Subject MP08\_0207 & MP10\_0219 - Avon and Beechworth Roads, Pymble

The NSW Department of Planning and Infrastructure (DP&I) is currently assessing a major project application for a residential development at Avon and Beechworth Roads, Pymble. Arup has prepared this document on behalf of the DP&I to provide an independent assessment of the key transport issues raised during the submissions period relating to the proposed application.

To	Helen Mulcahy	Date 29 May 2013
Copies	Ben Lusher	Reference number JDM/230501
From	Joshua Milston	File reference
Subject	MP08_0207 & MP10_0219 - Avon and Beechworth Roads, Pymble – Supplementary Transport Advice

Figure 1 Existing Pedestrian Connections

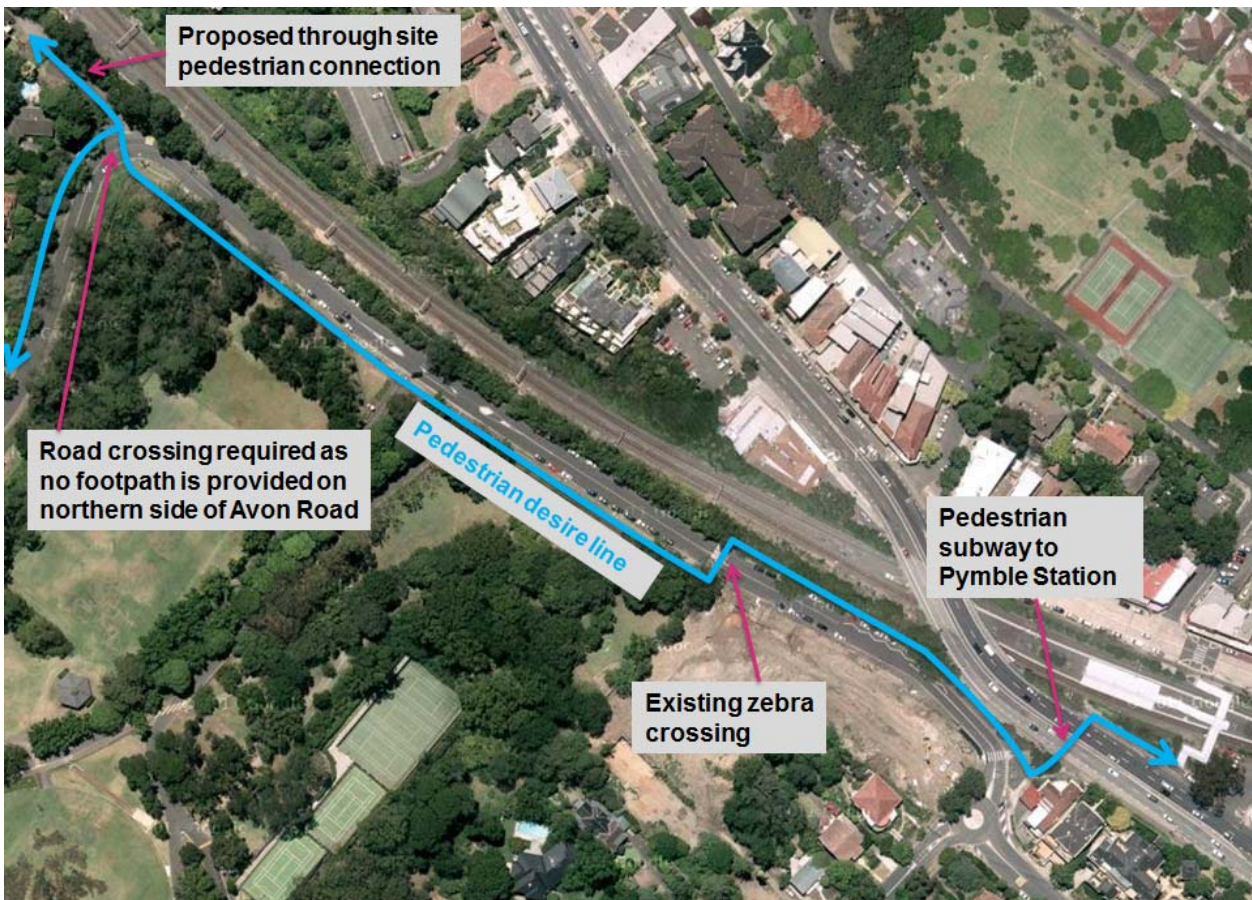
Pedestrian access along Avon Road adjacent to the Concept Plan site is currently limited to the southern footpath. A zebra crossing is provided opposite the pedestrian entry to Pymble Ladies College, with an additional subway connection providing access to Pymble Railway Station. This is summarised in Photographs 1 and 2, as well as Figure 1.

Following the development of the Concept Plan site, there will be a high volume of pedestrians walking to and from Pymble town centre (including the railway station) during the morning and evening peak periods. The current network would require pedestrians to cross Avon Road at the bend in the road, opposite the access to buildings 3 & 4.

Figure 2 Pedestrian Refuge at Site Access

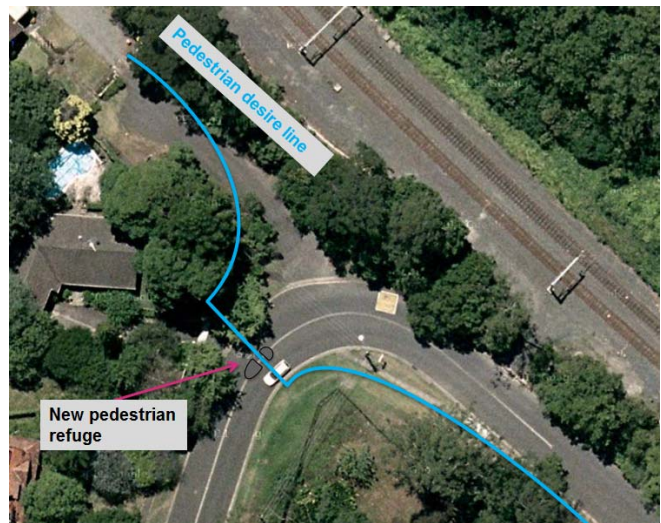
The installation of a 2m wide pedestrian refuge (similar to that shown in Photograph 2) was considered as it would allow a two staged crossing of Avon Road to the southern footpath. This is shown in Figure 2.

This option is limited however as it is unlikely the swept path of coaches used by PLC could safely manoeuvre around the raised median. Preliminary turning paths undertaken by Arup indicate the body of the vehicle would impact on pedestrians standing in the centre of the refuge. Arup could confirm this by obtaining a site survey of Avon Road, or having the proponent provide vehicle swept paths at this location - demonstrating a central refuge would impact on the path of travel for coaches.

Option 3 (pedestrian refuge at site access) is considered the most optimal in terms of pedestrian connectivity, however if this is not possible due to the movement of coaches, the proponent should further consider the arrangement outlined in option 4 above.

Figure 3 Pedestrian Refuge South of Site Access

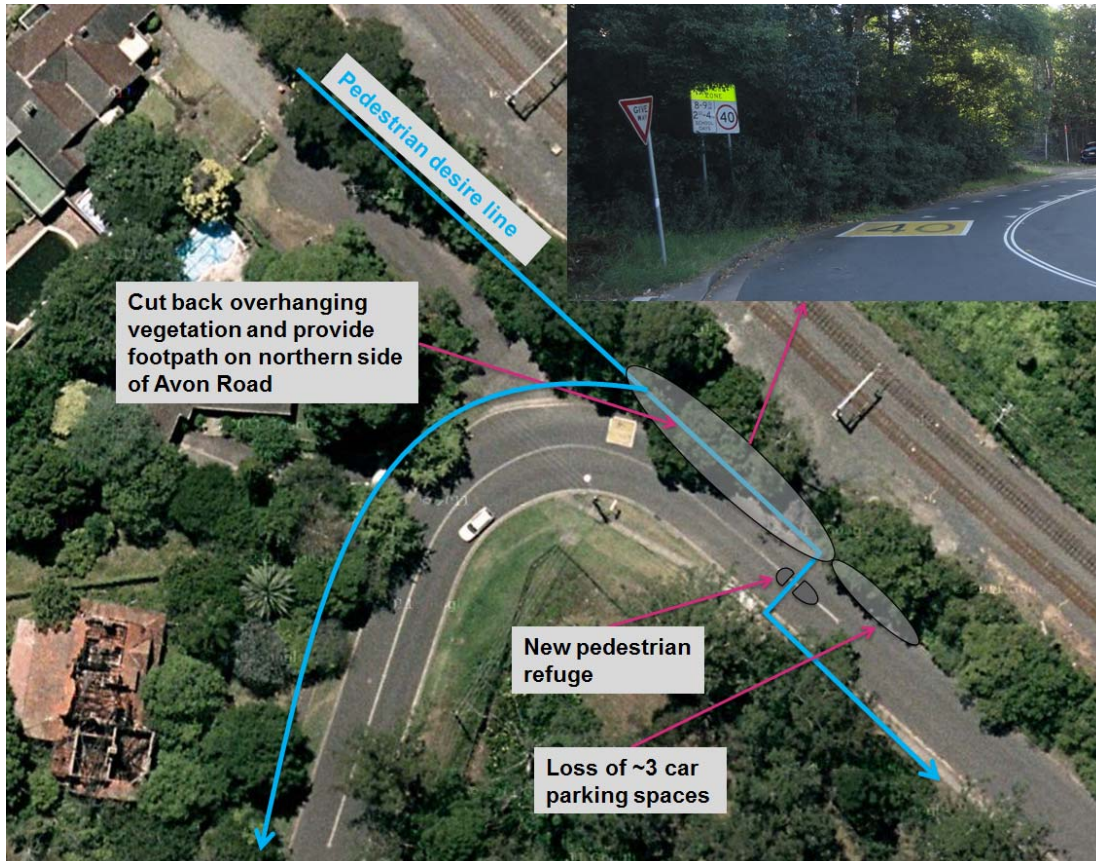
Given that the installation of a pedestrian refuge is unlikely to be possible at the bend in Avon Road, an alternative solution is to provide the refuge further south along Avon Road. This would require overhanging vegetation to be cut back on the northern side of Avon Road to provide a footpath up to the refuge, as well as the introduction of a no stopping zone which would impact three existing on-street car parking space. This option is summarised in Figure 3.

**Figure 4 Building 1 Servicing Arrangements**

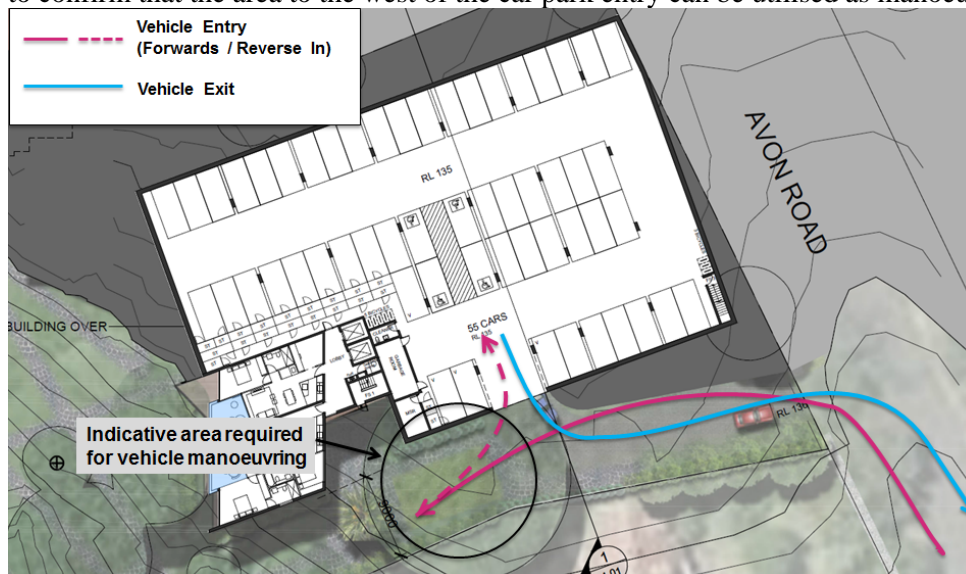
Arup has reviewed the proposed access arrangements and car park design for building 1, based on drawing DA 02.01 in Appendix G of the PPR. The following is noted:

- The design, including parking bay dimensions and aisle widths, is in accordance with AS2890.1 (Australian Standards for Off-Street Car Parking)
- The entry width of just over 6m is sufficient to accommodate vehicles simultaneously entering and exiting the building
- It is unclear how the development proposes to allow access for movements of garbage trucks and removalist vehicles into the basement car park. In the absence of any turning path analysis, Arup has indicated the likely access arrangements for these vehicles in Figure 4 below. The proponent would need to confirm that the area to the west of the car park entry can be utilised as manoeuvring space.

- To accommodate service vehicle movements into the basement for building 1, confirmation is required that the area to the west of the car park entry can be utilised as vehicle manoeuvring space

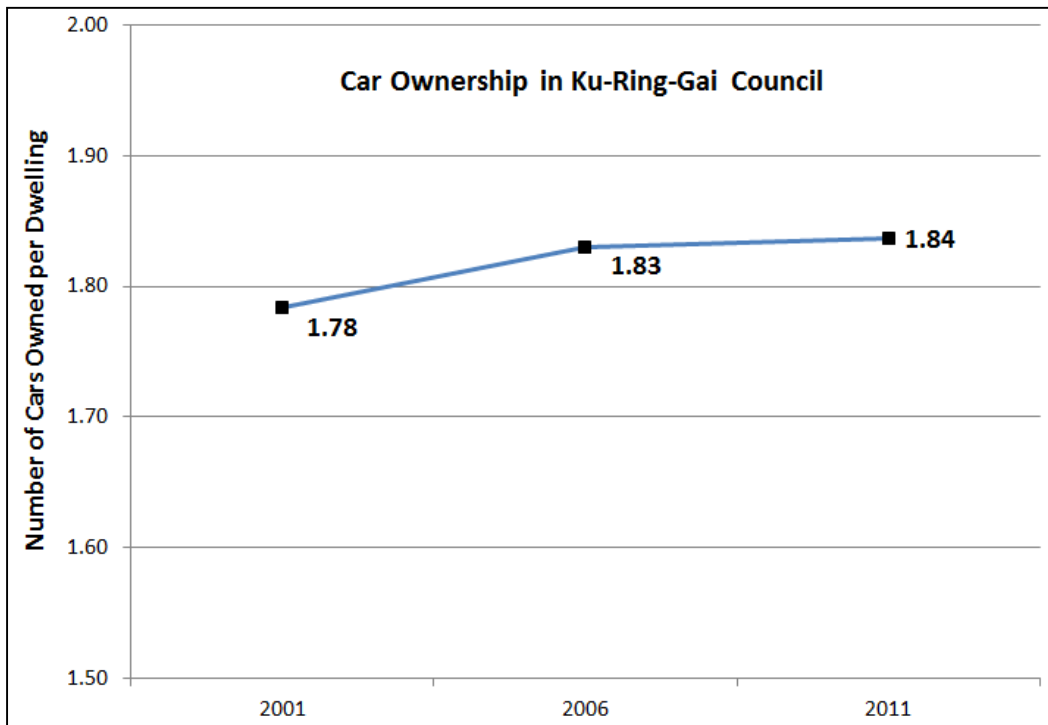
The crossing arrangement proposed by the proponent essentially provides a 'business as usual' outcome in relation to pedestrian movement, certainly not an optimal one. The realignment of the Avon Road footpath results in only minor reduction in crossing length, negligible in benefit as pedestrians walking to and from the railway station will still conflict with through traffic on Avon Road – particularly during the AM Peak Hour.

Throughout the documentation, the proponent has failed to demonstrate that a pedestrian refuge either at the apex of the bend on Avon Road, or further south as proposed by Arup, would not be feasible. Either of these options would provide a much improved solution for pedestrian connectivity. Considering that the traffic report asserts that the site is well connected to local public transport – much of this benefit will be lost if appropriate pedestrian links are not provided.

If a formal crossing on Avon Road is not possible, the arrangement proposed by the proponent will not lead to unacceptable safety implications for pedestrians crossing the road at this location. It should not act as a barrier for the development proceeding. However, in our opinion, this solution would only be considered reasonable after it could be demonstrated all other options have been proved impractical.
